DEPARTMENT OF THE ARMY  
JACKSONVILLE DISTRICT CORPS OF ENGINEERS  
10117 PRINCESS PALM AVENUE, SUITE 120  
TAMPA, FLORIDA 33610

Tampa Permits Section  
SAJ-2011-00551 (IP-TEH)

This is in reference to your permit application requesting Department of the Army authorization to impact waters of the United States in association with a project known as "Ridge Road Extension" (SAJ-2011-00551 (IP-TEH)).

By letter dated April 25, 2012, the U.S. Army Corps of Engineers (Corps) requested that you provide a revised wildlife survey plan for the proposed project. In consultation with the U.S. Fish and Wildlife Service (USFWS) and the Florida Fish and Wildlife Conservation Commission (FFWCC), the Corps has reviewed the revised wildlife survey plan dated May 25, 2012 and supplemental information provided on June 25, 2012. We request that you address the following in a revised plan:

**Attachment B.  
Red-cockaded Woodpecker  
Potential Habitat and Transect Map**

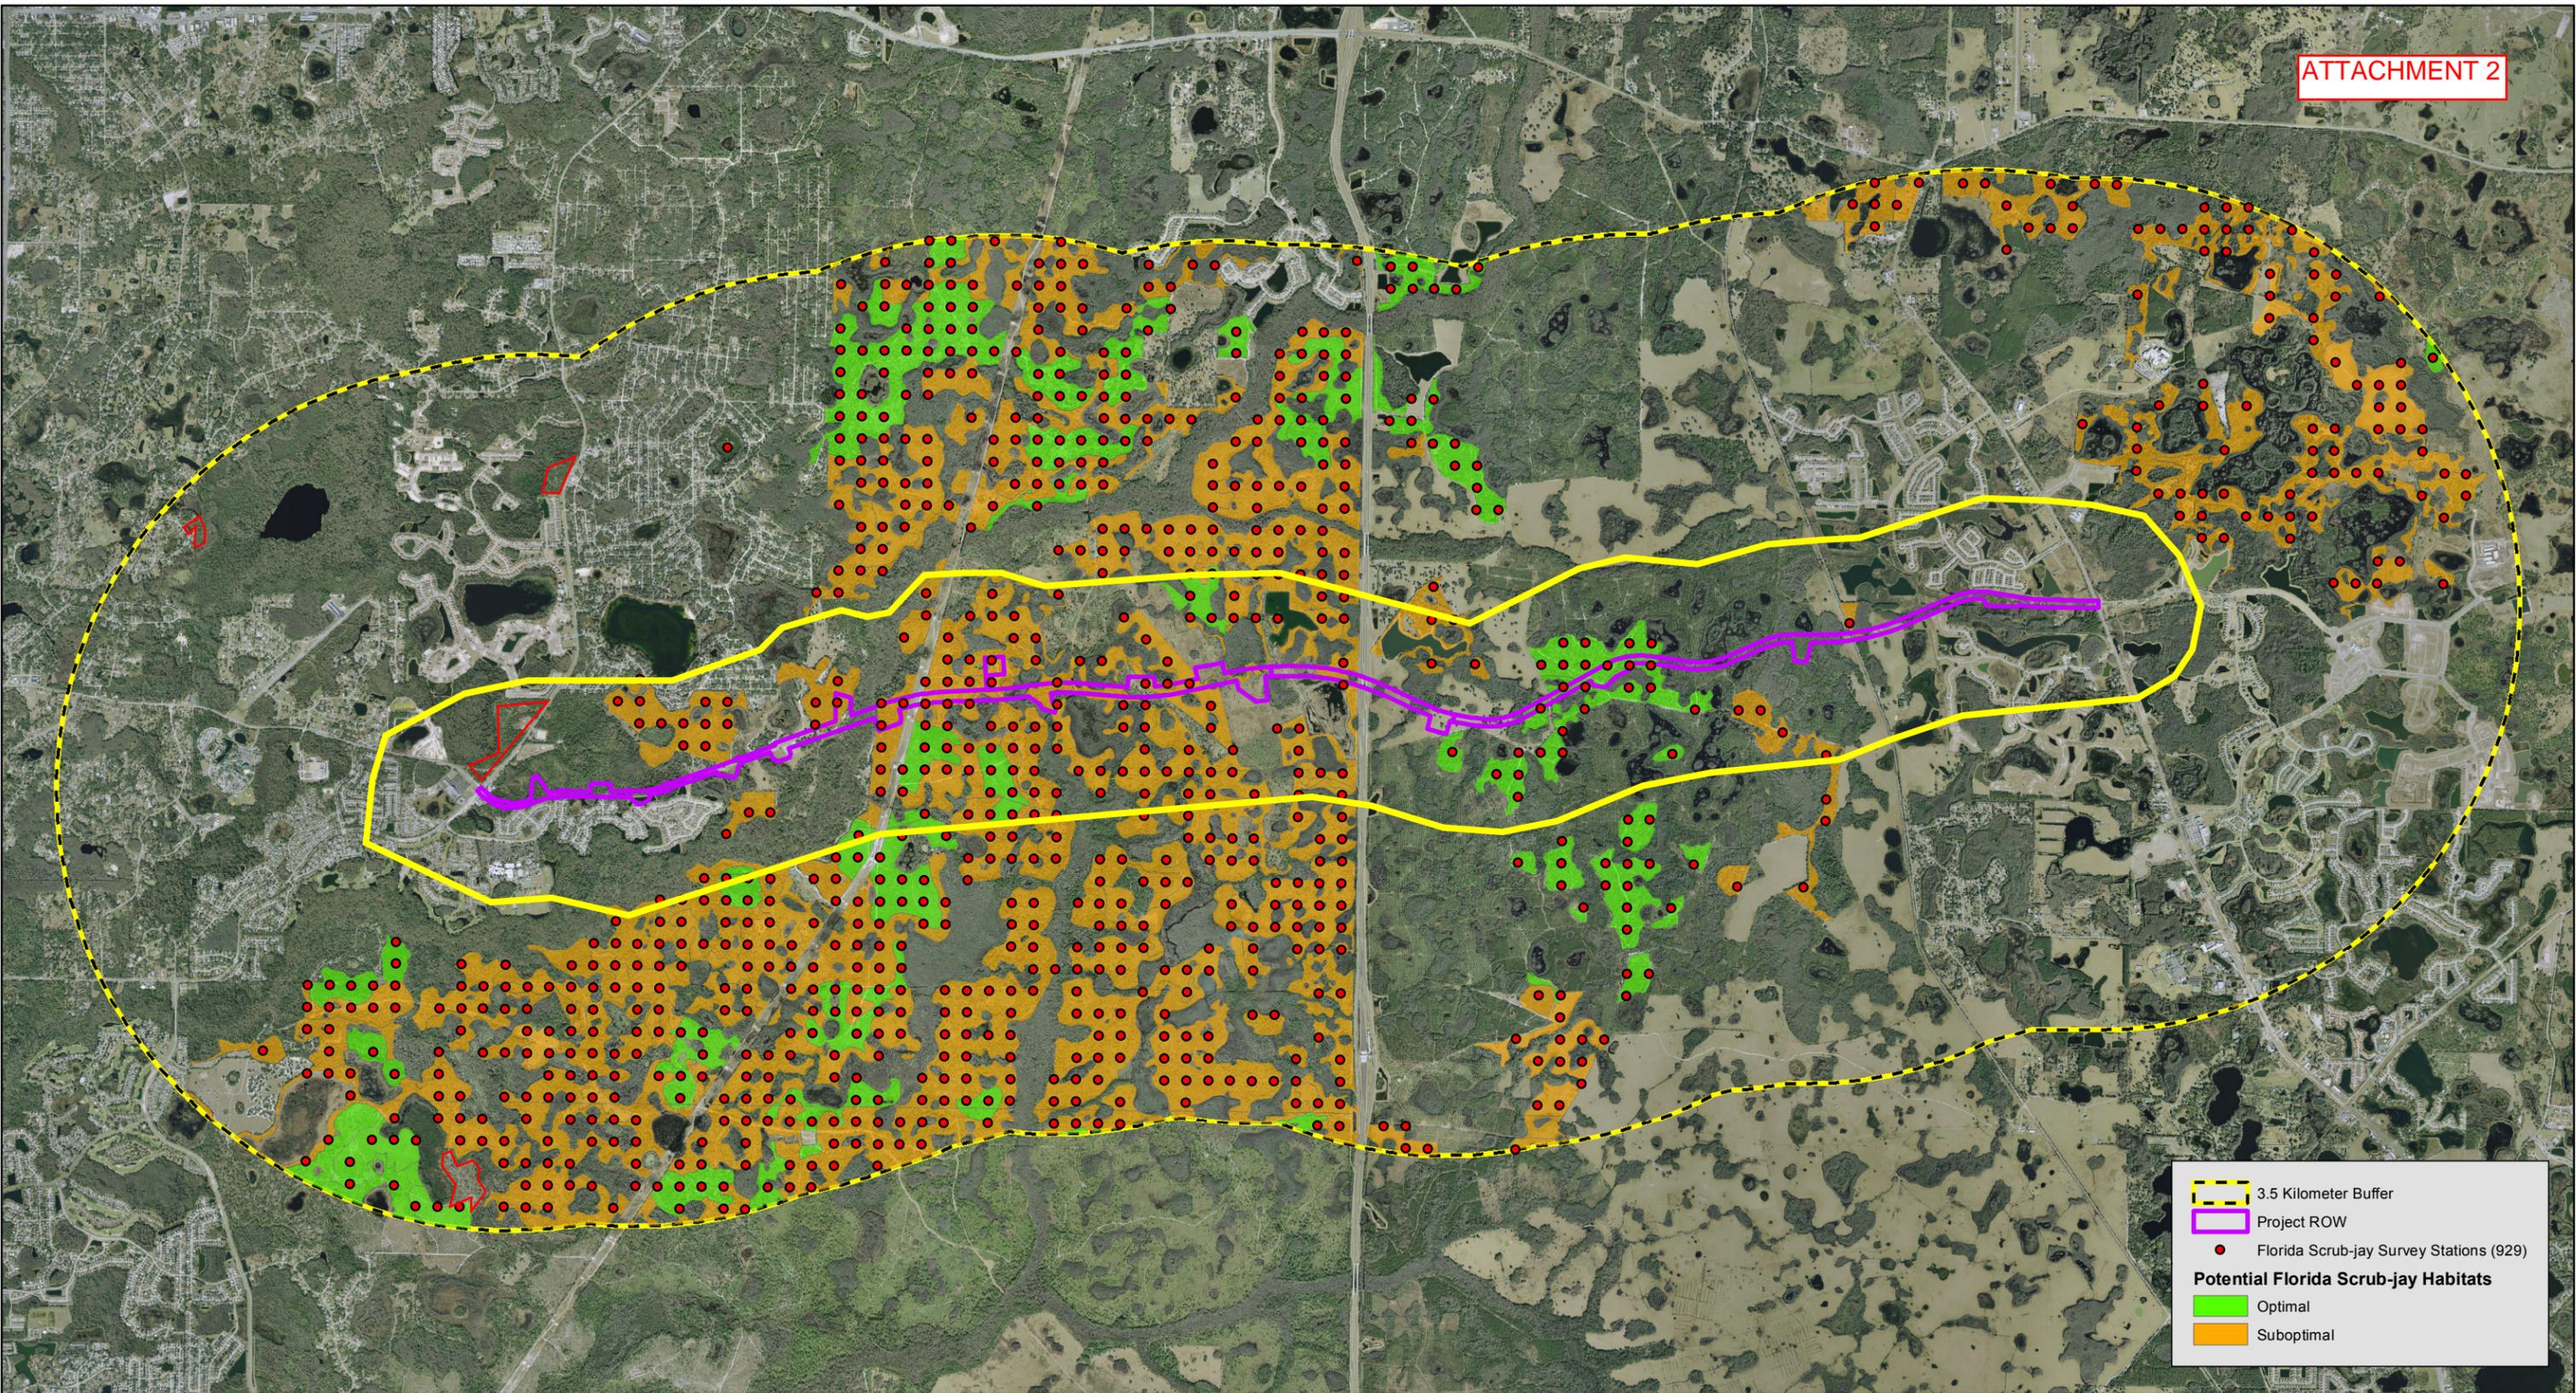
- a. Attachment B of the revised survey plan includes a map of areas to be examined for cavity trees. The Corps presumes that this map depicts areas that may serve as suitable foraging habitat prior to ground-truthing. However, there are large areas of habitat with a pine component that are not included (see Attachment 1 of this letter, which includes these areas outlined in red). These areas include pine flatwoods, long-leaf pine / xeric oak, and hardwood conifer mixed. There are also large areas of pine plantation not marked on this map that may serve as suitable foraging habitat. The Corps requests that you address these areas by providing the specific process by which areas were selected or disqualified for examination for cavity trees as depicted on Attachment B of the revised survey plan.
